AP1000 Phase 2 review  
Staff's meeting with Westinghouse

January 23, 2002

# AP1000 Scaling Evaluation

# AP1000 Scaling

## **Simplified ADS Transient Calculation**

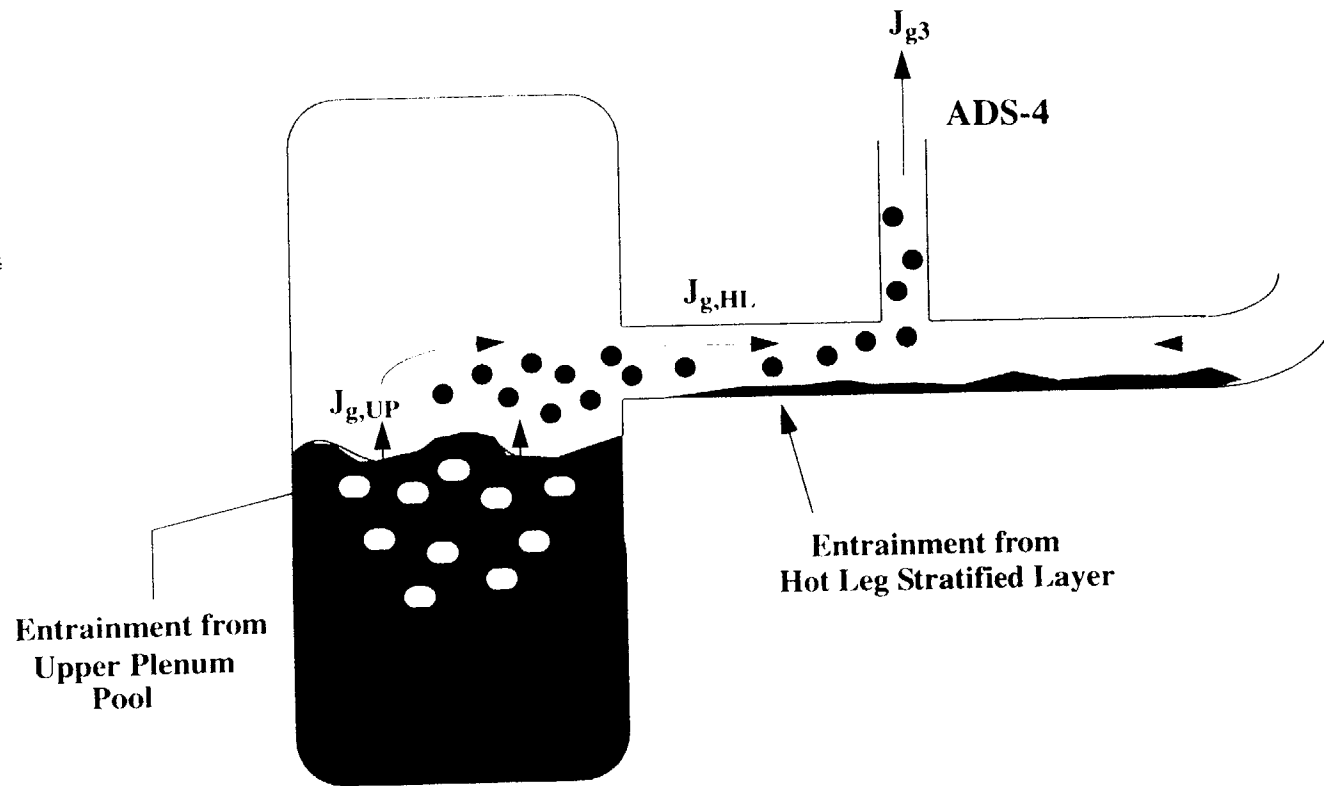
◆ Depressurization rates of AP1000 and AP600 are similar. Transient time scales are about the same.

◆ ADS-4 flow quality is a dominant uncertainty contributor. Low quality ADS-4 flow (i.e. high entrainment in upper plenum and/or hot leg) will deplete the AP1000 vessel inventory significantly faster than AP600 or test facilities.

◆ Suggests that entrainment and carry-over from RCS to ADS-4 branch line is important effect on comparative results.

- Entrainment from Hot Leg Stratified Layer
- Westinghouse approach used typical correlation for entrainment onset:

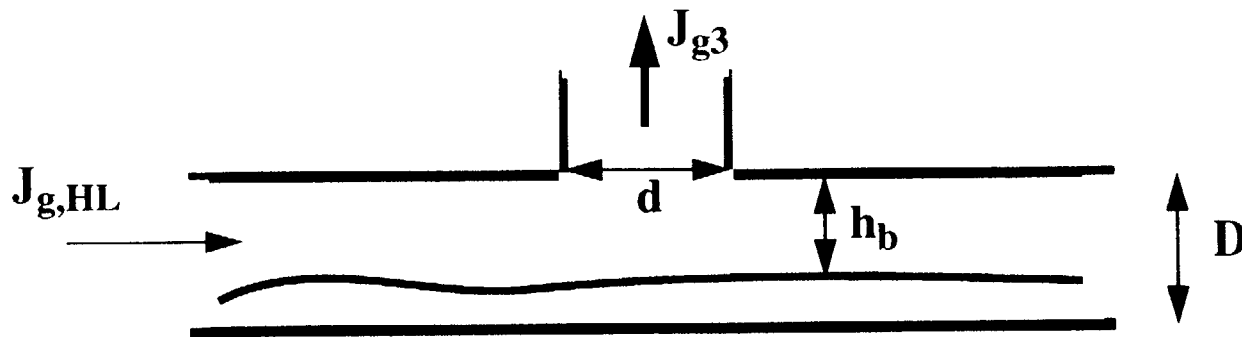
- Assuming correlation is valid, what is non-dimensional entrainment onset height? Alternately, to what level could water drop before entrainment stopped?

- In all periods, entrainment onset could occur for a lower water level in AP1000 than in integral tests. (approx. 52% increase in  $h_b/D$  for ADS venting, 35% in IRWST)

*hard to judge quality of test data based on these numbers*

## Conclusions

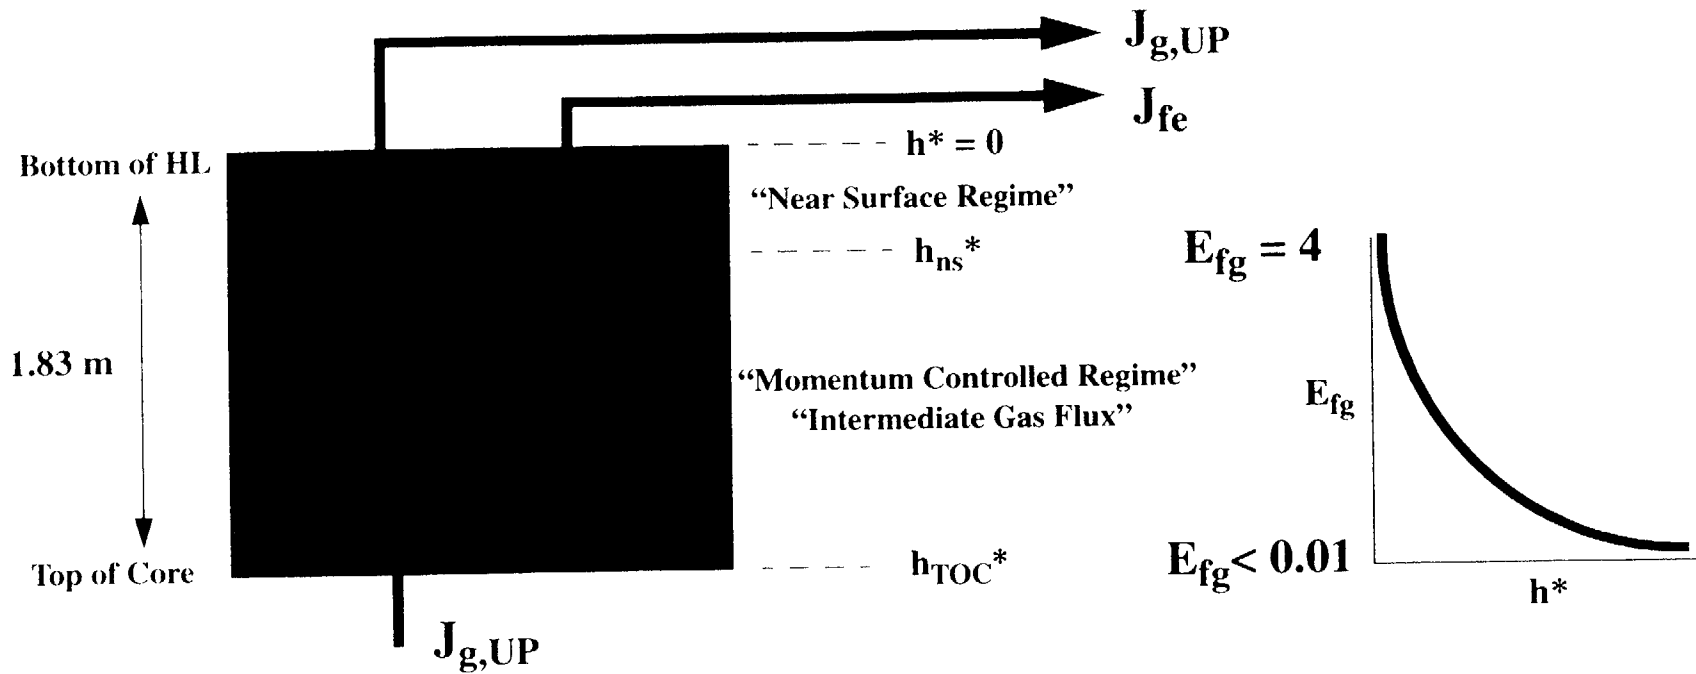
- ◆ In general, integral tests performed to validate codes and confirm behavior of AP600 remain valuable and can be used AP1000 code validation.
- ◆ Entrainment and carry-over from vessel & hot leg to ADS-4 expected to have an important impact on vessel inventory during the SBLOCA periods when inventory is near a minimum. ADS-4 flow quality is a concern.

- ◆ Entrainment & carry-over processes are not well understood. Existing correlations are geometry & T/H range of condition dependent. Difficult to reliably extend these correlations to complex geometry in AP1000 UP and HL-branch line. They do however, suggest significantly higher entrainment in AP1000.

- ◆ It has not been demonstrated that entrainment data from integral test facilities is correct the range of conditions for AP1000, as is therefore not considered appropriately scaled to validate entrainment models in thermal-hydraulic codes. Alternate data or revised approach is necessary to validate entrainment modeling for AP1000.

- **Range upper plenum and hot leg entrainment rates over sufficiently large range in plant & APEX simulations. Demonstrate that margin to core uncover remains large even for “extreme” entrainment rates. Show that time to deplete UP mass >> ADS-4 transition time. Problem: How to establish range.**
- ◆ **Use experimental data from a SET facility with large d/D branch line, and upper plenum pool entrainment data from APEX or elsewhere to develop improved models and/or establish appropriate bound. Problem: Scaling issues, atypicalities in SET flow regimes (oscillations), APEX UP geometry.**
- ◆ **Incorporate DOE-NERI sponsored tests to be run in APEX at AP1000 scaled power & system configuration into code validation for AP1000.**
